ArevaEPRDCPEm Resource

From: WELLS Russell D (AREVA NP INC) [Russell.Wells@areva.com]
Sent: Tuesday, June 30, 2009 7:52 PM
To: Tesfaye, Getachew; Miernicki, Michael
Cc: Pederson Ronda M (AREVA NP INC); BENNETT Kathy A (OFR) (AREVA NP INC); DELANO Karen V (AREVA NP INC)
Subject: Response to U.S. EPR Design Certification Application RAI No. 103, FSAR Ch 16, Supplement 2
Attachments: RAI 103 Supplement 2 Response US EPR DC.pdf

Response to
Request for Additional Information No. 103, Supplement 2

QUESTIONS for Technical Specification Branch (CTSB)

Figure 7.3-3—EFWS Actuation

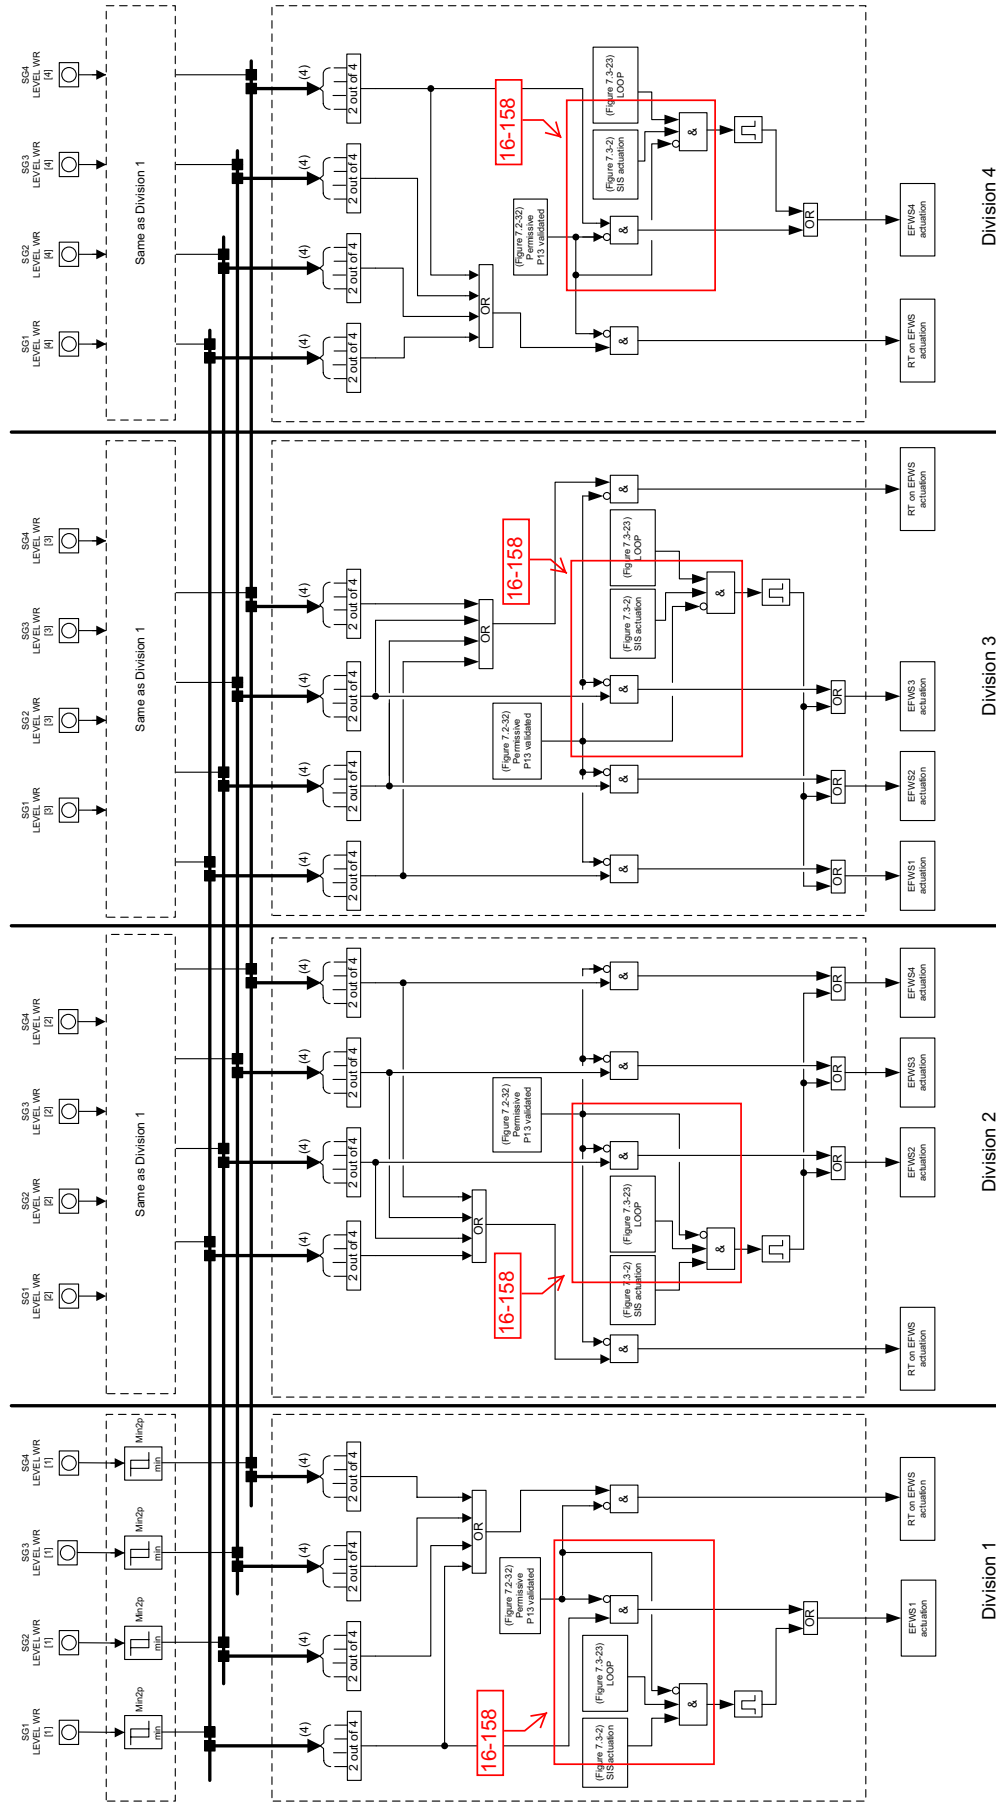
The EPR FSAR, Section 7.3.1.2.2 and logic drawing 7.3-3, indicate that the EFWS is actuated on either "Low-Low SG Level" or "Loss of Offsite Power and SIS Actuation." The EPR FSAR, Section 7.3.1.2.2 states that "in both cases, EFWS actuation is bypassed when hot leg temperature is below the P13 permissive setpoint." The EPR Bases, Section B.6.b (pg B 3.3.1-37, last sentence) states that "there are no automatic permissives associated with this function." These statements are inconsistent. The correct permissive logic needs to be identified and documented consistently throughout the EPR Bases and FSAR. Conflicting statements need to be corrected with sufficient information to provide a clear understanding of the facts, as appropriate.

U.S. EPR FSAR Tier 2, Chapter 7, Figure 7.3-3— EFWS Actuation and U.S. EPR FSAR Tier 2, Chapter 16, Technical Specification Bases 3.3.1 "Protection System (PS)" will be revised to show that Emergency Feedwater (EFW) Actuation on Loss of Offsite Power (LOOP) and Safety Injection System (SIS) Actuation will be enabled when the hot leg temperature is greater than or equal to 200°F (P13 inhibited).

U.S. EPR FSAR Tier 2, Figure 7.3-3 will be revised as described in the response and indicated on the enclosed markup.

Figure 7.3-22—CVCS Isolation for Anti-Dilution

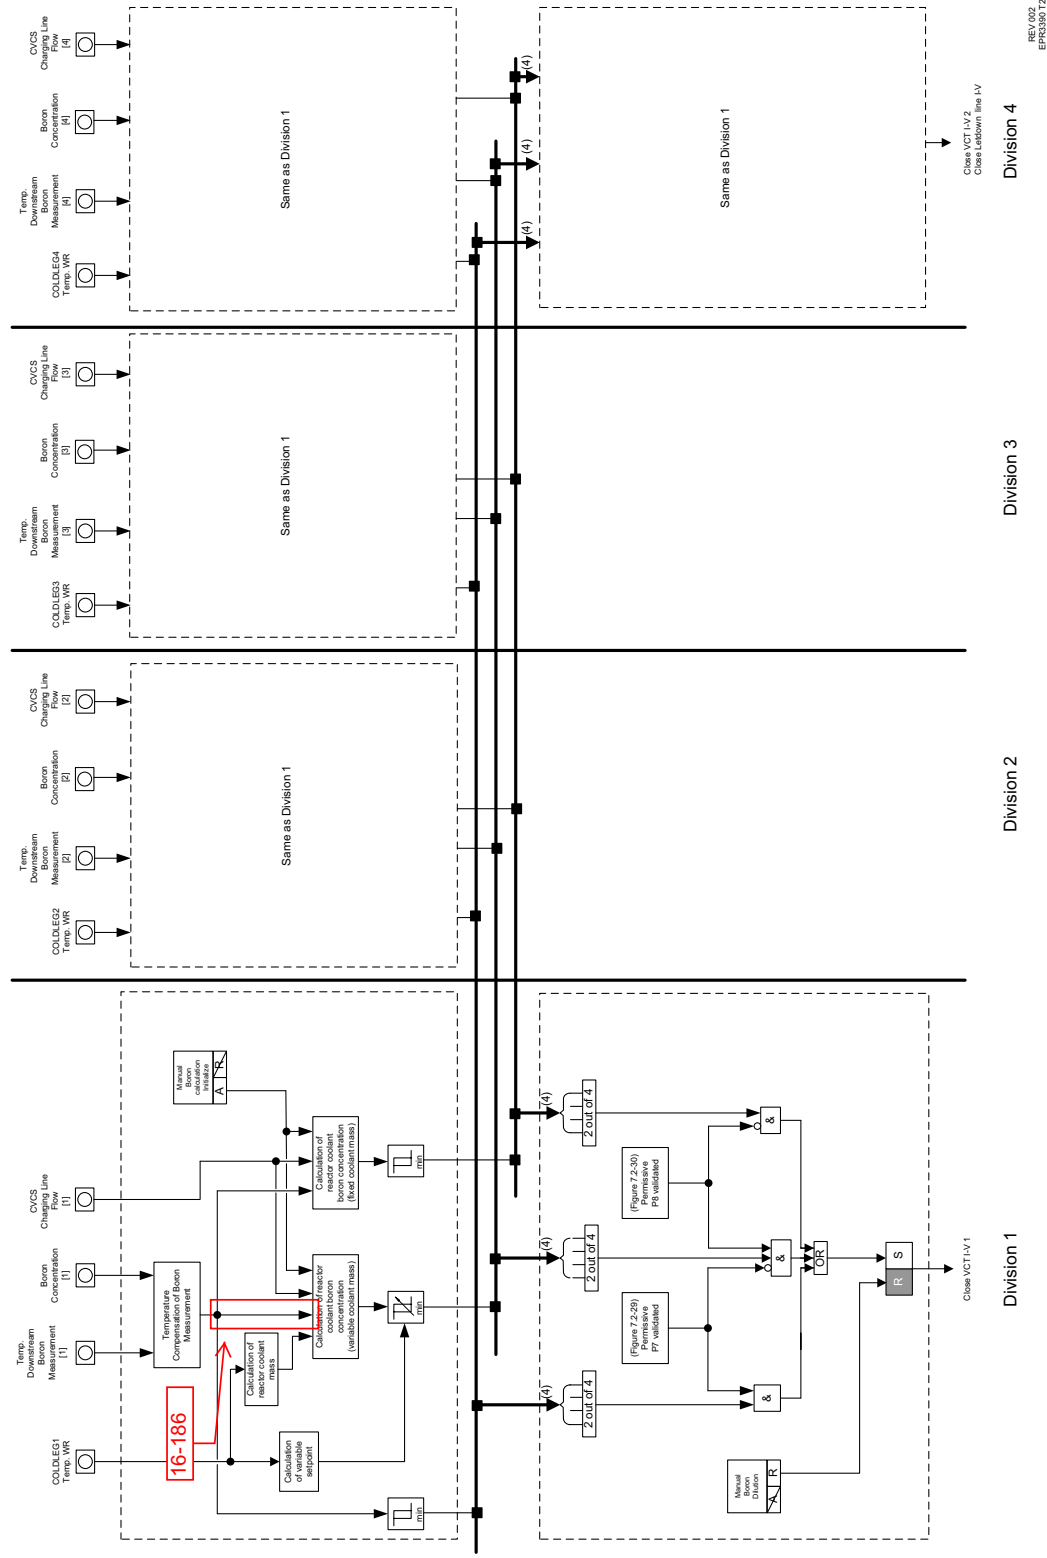
The EPR FSAR, ESFAS Function B.11.b and B.11.c Anti-Dilution Mitigation Logic Diagram, Figure 7.3-22, appears to have a missing electrical connection tie between the “Temperature Compensation of Boron Measurement” block and the “Calculation of Reactor Coolant Boron Concentration Variable Coolant Mass” block. Verify the overall correctness of Figure 7.3-22. Correct the logic diagram as necessary. If it is determined that an electrical connection tie is not needed between the “Temperature Compensation of Boron Measurement” block and the “Calculation of Reactor Coolant Boron Concentration Variable Coolant Mass” block, provide an explanation as to how the “Reactor Coolant Boron Concentration Variable Coolant Mass” can be calculated without a “Temperature Compensated Boron Measurement” input.

U.S. EPR FSAR Tier 2, Figure 7.3-22—Anti-Dilution will be revised to show an arrow originating at the Temperature Compensation of Boron Measurement Block function and ending (providing input) to the calculation of Reactor Coolant Boron Concentration (Variable Coolant Mass) block.

U.S. EPR FSAR Tier 2, Figure 7.3-22 will be revised as described in the response and indicated on the enclosed markup.
